July 9, 1980
TLL 283

Three Mile Island Nuclear Station, Unit II (TMI-2)
Operating License No. DPR-73
Docket No. 50-320
Submerged Demineralizer System Technical Evaluation Report

Your letter NRC/TMI-80-89, dated May 16, 1980, requests additional information to enable your evaluation of the subject report.

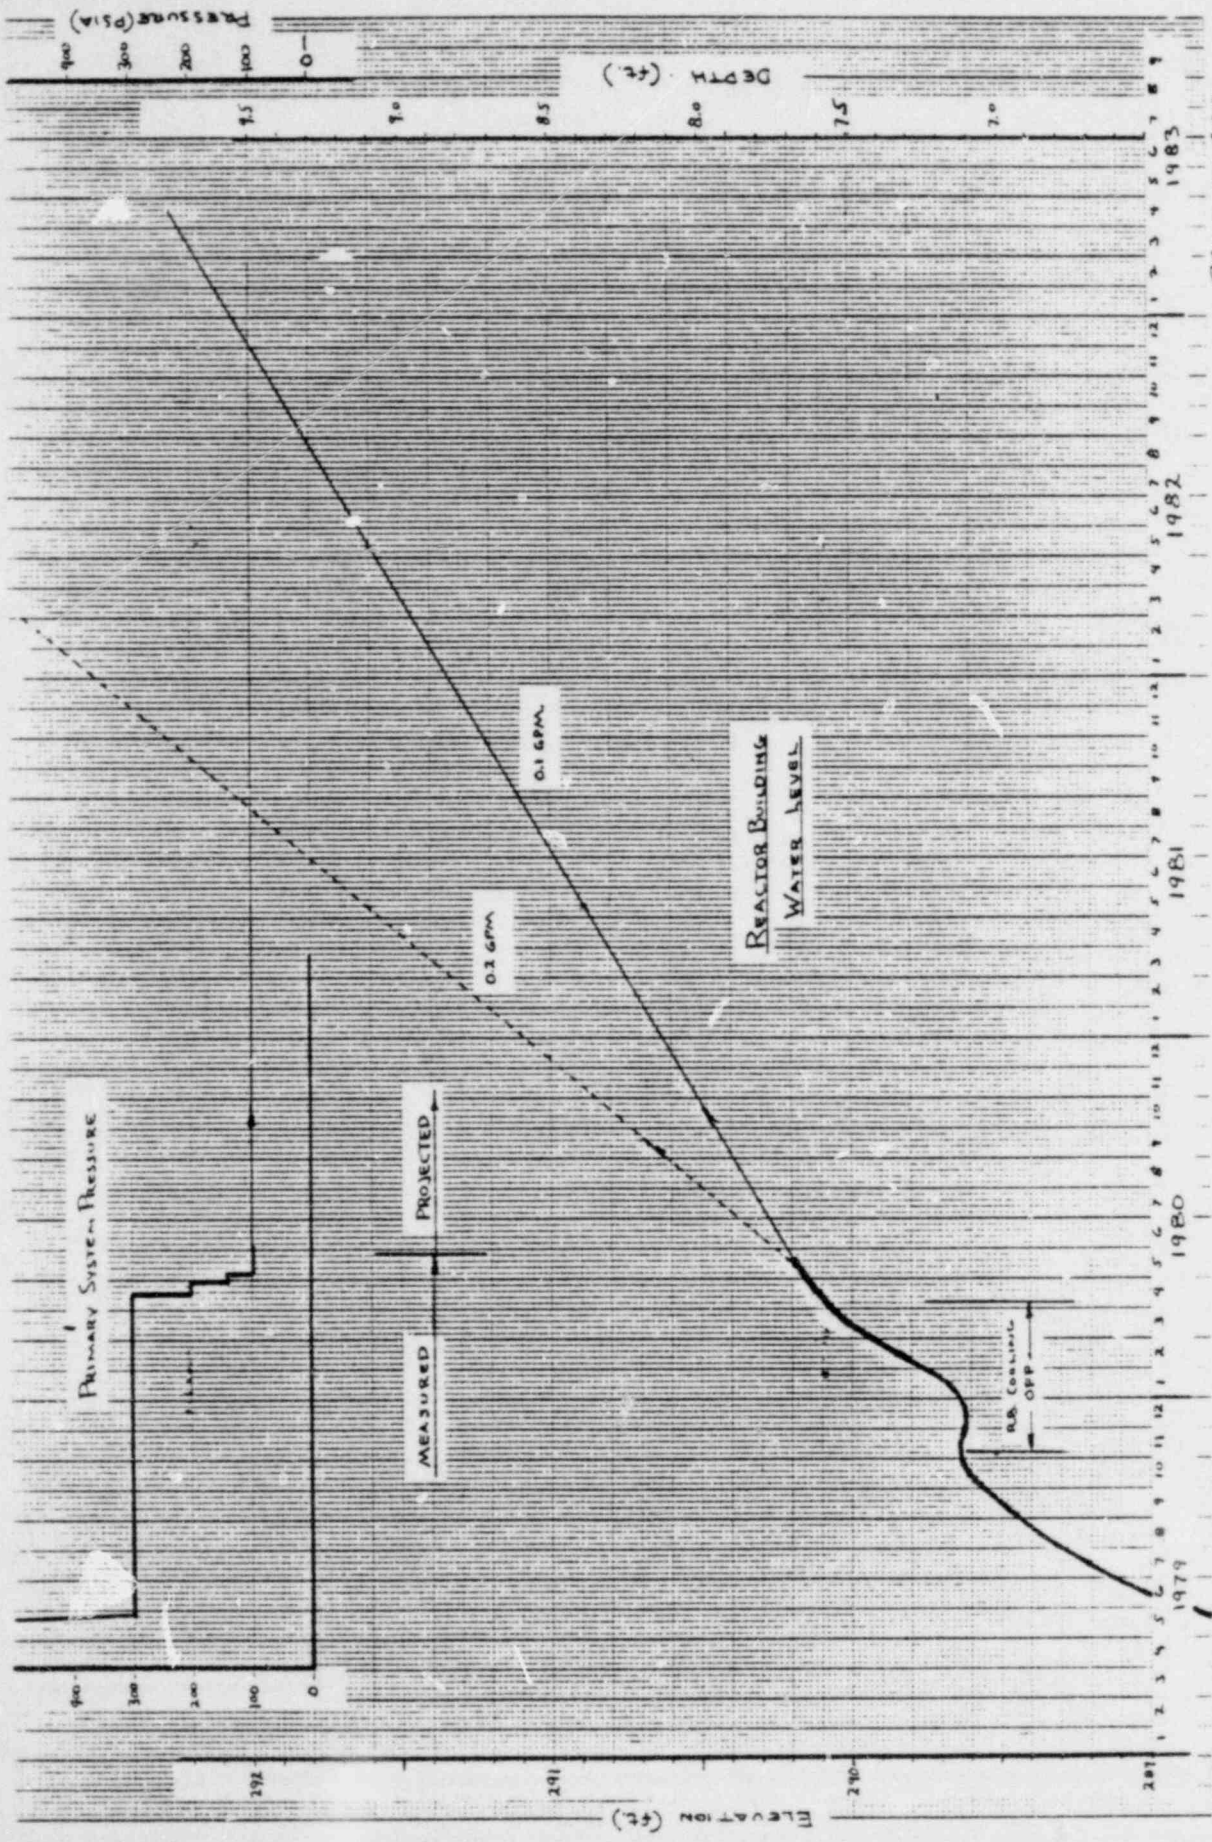
Based on past experience, project the Reactor Building water level for the next two years and list the critical instruments that may be affected by the water level you projected.

2.1 The projected water level in the Reactor Building for July 1, 1982 is 291.7 feet or a depth of 9.2 feet from the RB floor. This projection is based on the current water depth of 7.7 feet (as of May 15, 1980) with an inflow leakage of ~ 0.1 gpm from the Reactor Coolant System (RCS). This inflow leakage rate has been detected during the period of time that the RCS has been maintained at a pressure of ~ 100 psi (DVM).

As a bounding (worst case) estimate - a higher leak rate was also studied. An inflow leakage of 0.2 gpm was indicated from sump level measurements during the time that the RCS was maintained at ~ 300 psi. Thus, an upper elevation of the water depth could be 10.7 feet by July 1982 should the RCS pressure be returned to 300 psi. The projected depth at the postulated leakage rate of 0.2 gpm would be 293.2 feet.

A plot of the measured Reactor Building water level indicates that a fluctuation can be expected from deactivation of the Reactor Building Cooling Water. This type of action allows the R.B. humidity level to approach 100%. As condensation occurs on all components that are cooler than air, the sump water is transferred to higher elevation collection areas. When these collection areas become saturated or filled, the accumulation rate in the sump resumes at a rate matching the inflow leakage rate. When the RB cooling water is activated the collected water evaporates due to the lower humidity and is returned to the sump by condensing at the cooling coils which are drained into the sump. The type of water accumulation fluctuation shown by this figure is expected to occur seasonally, thus, the projected straight line increase of 0.1 gpm will fluctuate depending on RB Cooling System operation, but the average leakage from the RCS will be 0.1 gpm.

BLOWDOWN SETUP FOR CNSI-TMI FILTERS

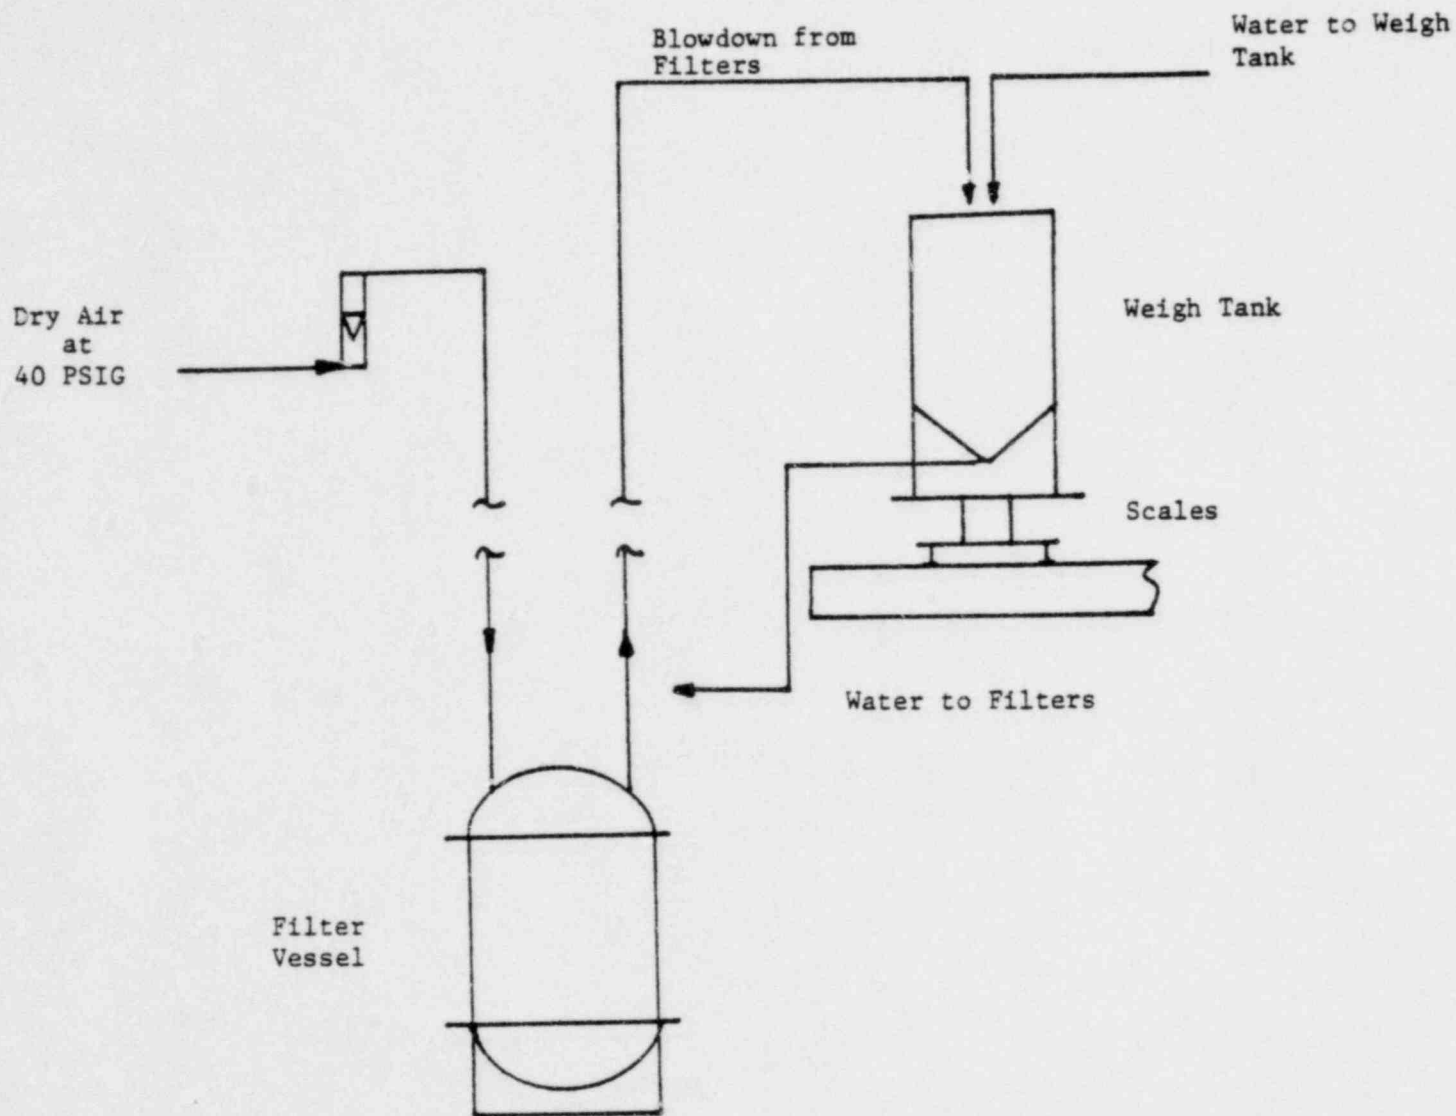
Provide the administrative surface dose rate limit for change out of the SDS filters.

After the initial amount of water was discharged, two blowdowns each at 10 minutes, 2 hours, 4 hours, 8 hours, and 24 hours were performed. After each blowdown, the vessel was visually inspected for wetness and the plug was removed to collect and measure the remaining water. To simulate actual conditions, the filter vessel was tested at approximately 20 feet below the weigh tank. A blowdown was also accomplished underwater to simulate remote conditions. (Figure No. 1 shows details of setup.)

After the filter unit was dried, lead was added for ballast. The extra weight enabled the filter to remain submerged after drying and added sufficient stability to the filter vessel to prevent it from shifting during hookup operations. The filter units were pressurized and submerged under approximately 20 feet of water and stored for 48 hours. After storage, the filters were removed from the pool and inspected for water.
